Hadley Smart Valve – Raising Suspension – Progress Update

Concern: Hadley Smart Valve causing rear suspension ride height to inflate to max

Affected Models: 4th Generation Cascadia

Fig. 1, Hadley SmartValve

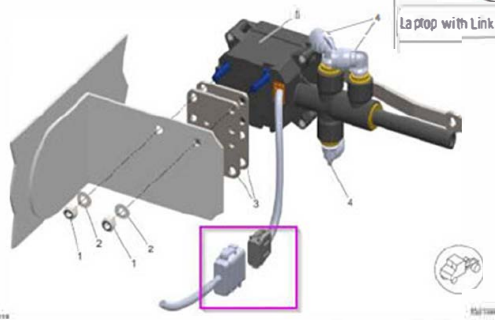
Root Cause: Software bug causing unintended raised suspension while in bobtail mode

Correction: Current Field Fix: Replace valve with latest p/n OR Laptop + CAN cable firmware to locations w/ highest concentration of trucks (via connection @ highlighted)

Production Changeover Date: December 2025 (any parts received now are the latest version)
